Draft Variation to the Territory Plan No 355 -
Calwell Group Centre

Submission on Inquiry into Draft
Variation to the Territory Plan
No. 355 – Calwell Group Centre

RE: Calwell Centre - Submission on Territory Plan Draft Variation 355

FIGURE 1 OF RECOMMENDED V355 (SUBJECT TO INTERIM EFFECT FROM 10 AUGUST 2018)

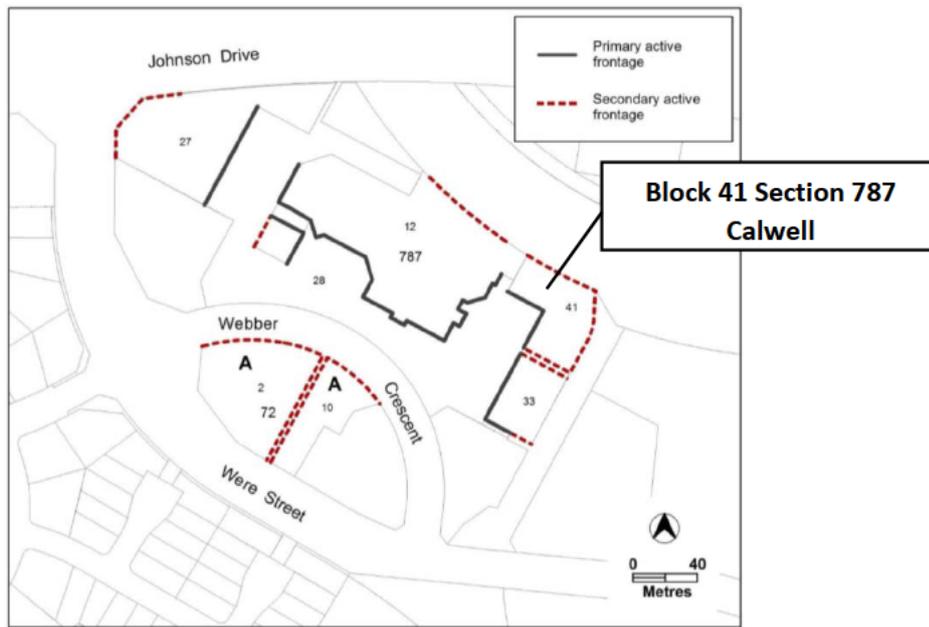
Block 12 and 41 will be included into the CZ1 zoning as a result of this variation – this change is welcome (assuming that Block 41 may be used for commercially viable uses at ground level, including residential use to the stormwater channel and pedestrian pathway).

<p>R4 (newly expressed separately)</p>	<p>This is a mandatory requirement. There is no applicable criterion.</p>	<p>Newly expressed as mandatory.</p>	<p>The impact on development opportunities at Block 41 is substantial as the developable area for residential on the site</p>

<p>R14</p> <p>For new buildings located along primary active frontage areas identified in figure 1, frontages and building design comply with all of the following:</p>	<p>This is a mandatory requirement. There is no applicable criterion.</p>	<p>Upon the advice of TCCS and in order to better reflect the master plan recommendations, the ground floor of block 41 will be exclusively commercial uses.</p>	<p>The control as described remains overly prescriptive and this would prevent innovative design outcomes on the site which may make pursuit of redevelopment on Block 41 unfeasible, meaning future development of the Centre may not occur,</p>

Rule	Criteria	Consultation Response	Concern
<p>a) buildings incorporate clear display windows and/or shop fronts at the ground floor level</p> <p>b) buildings incorporate direct pedestrian access at grade with the verge level for access and egress for persons with disabilities</p> <p>c) any small areas of walls without windows contain displays, showcases and/or public art, with a maximum of 30% blank frontage per tenancy</p> <p>d) open structured car parks and/or loading docks are not located along the frontage.</p>		Residential uses will not be permitted.	<p>especially with the prohibition of residential use at ground level at Block 41.</p> <p>Suggest introducing criteria to provide alternative design solutions that would assist to make development feasible in these areas.</p>
There is no applicable rule	<p>C15</p> <p>For buildings located along secondary active frontage areas identified in figure 1, frontages and building design complies with all of the following:</p> <p>a) commercial buildings incorporate clear display windows and shop fronts at the ground floor level</p> <p>b) buildings incorporate direct pedestrian access at grade with the verge level for access and egress for persons with disabilities</p> <p>c) building facades are not dominated by extensive lengths of blank facades, open structured carparks, loading docks,</p>	<p>Upon the advice of TCCS and in order to better reflect the master plan recommendations, the ground floor of block 41 will be exclusively commercial uses.</p> <p>Residential uses will not be permitted. The secondary active frontages are applicable to future commercial ground floor uses.</p>	<p>Failing to consider residential use at ground level along the secondary frontages of Block 41 is likely to result in any future development opportunity at the site to become non-viable.</p> <p>Suggest reducing the requirement for secondary active frontage for Block 41 in Figure 1 of the draft Code and permit residential development at ground level.</p>

FIGURE 3 OF RECOMMENDED V355 (BUILDING HEIGHT CONTEXT)

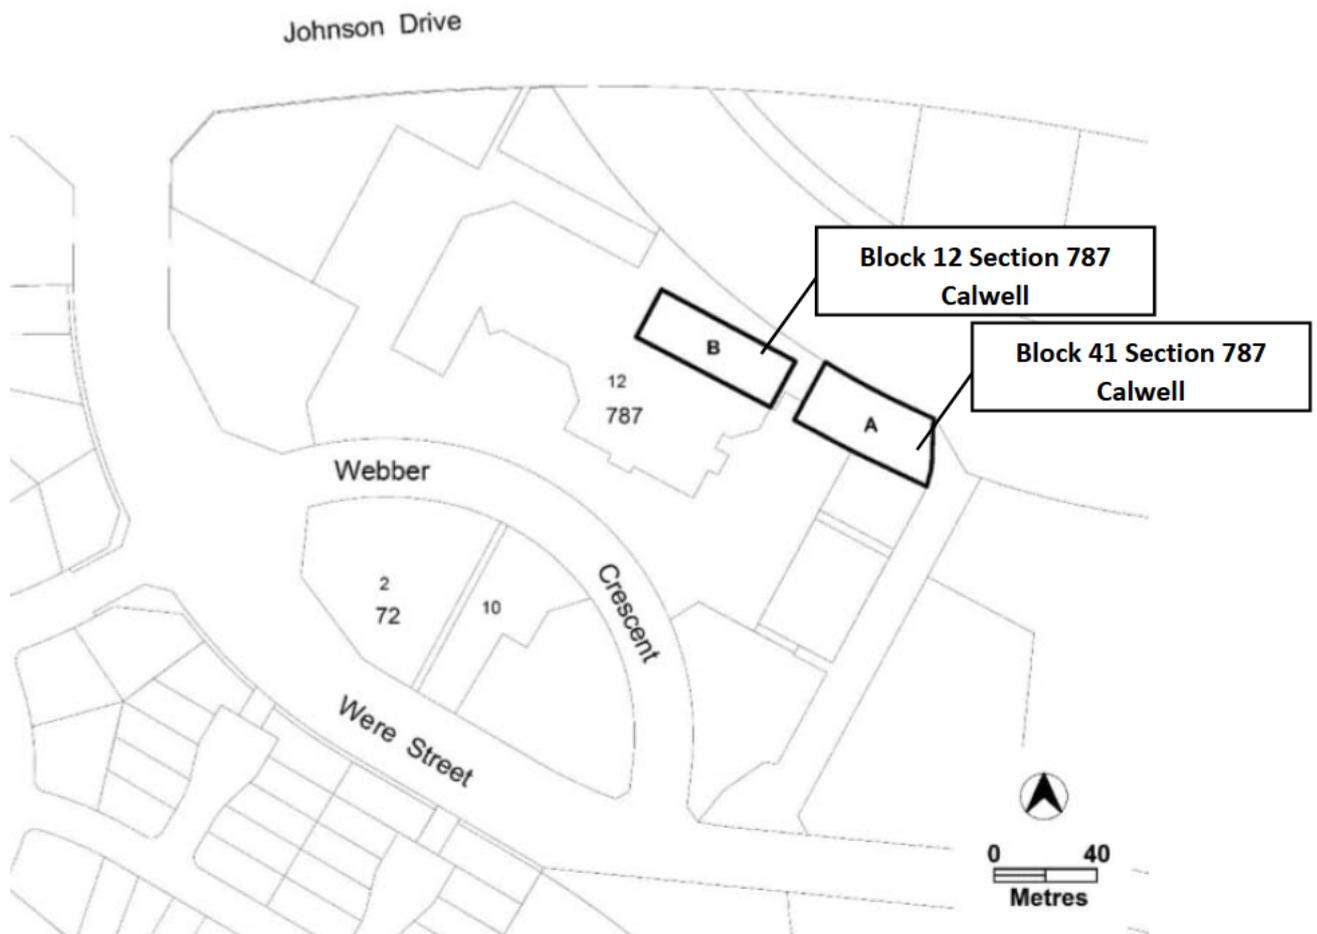
Rule	Criteria	Consultation Response	Concern
<p>The maximum height of buildings is 2 storeys except areas A and B in Figure 3. Plant room set back a minimum of 3m from the building facade of the floor immediately below is not included in the number of storeys</p>		<p>There remains some concern that the shape, form and development opportunity at Areas A and B are unlikely to result in development outcomes of the Master Plan. Area B located above the retail anchor is unlikely to become viable in a timeframe that would support the master plan timing expectations. The expression of development potential in Area A is unlikely to permit residential development at Block 41 given the other planning controls that dictate a very specific and narrow planning outcome that is unlikely to render a viable development outcome at the site.</p>	<p>is now very limited and most likely non-viable.</p> <p>The location of Area B at Block 12 will not result in a development opportunity in the term of the master plan (15 years) given the tenancy arrangements with the anchor tenant. To realise the master plan development objective and potential expressed in area B, an alternative opportunity would be required.</p>

<p>R5 This rule applies to areas A and B in Figure 3. The maximum height of building in areas A and B is 2 storeys.</p>	<p>C5 The maximum height of building in areas A and B may be increased to 4 storeys where: a) development maintains reasonable solar access on the surrounding publicly accessible areas. b) area A achieves all of the following:</p>	<p>The criteria C5 and C9 have been amended to reflect reasonable consideration of solar impact.</p>	<p>This change to consider reasonable impact is supported.</p> <p>Matters relation to the likely implementation of the development objectives expressed at Areas A and B are addressed at the R/C4 consideration above.</p>

Rule	Criteria	Consultation Response	Concern
	<p>i) is contained within block 41 section 787 Calwell</p> <p>ii) is measured from the north western most boundary of block 41</p> <p>iii) is a maximum of 26 metres wide.</p> <p>c) area B achieves all of the following:</p> <p>i) is contained within block 12 section 787 Calwell</p> <p>ii) is measured 10.5metres from the western boundary of area A</p> <p>iii) is a maximum of 22 metres wide</p> <p>iv) is a maximum of 60 metres long.</p>		
<p>R6</p> <p>This rule applies to development along primary and secondary active frontages shown in figure 1.</p> <p>The minimum floor to ceiling height at the ground floor level is 3.6m.</p>	<p>C6</p> <p>The ground floor level of buildings is adaptable for commercial uses.</p>	<p>Not considered in consultation report</p>	<p>Application of the rule to Block 41 if a mixed-use development was envisaged would result in an inefficient design that would be difficult to construct and therefore development of the site would not be feasible.</p> <p>Noting that the form of RV355 does not permit residential development at ground level at Block 41 this matter may be mute except if consideration is given to reconsider the use locality consideration.</p>
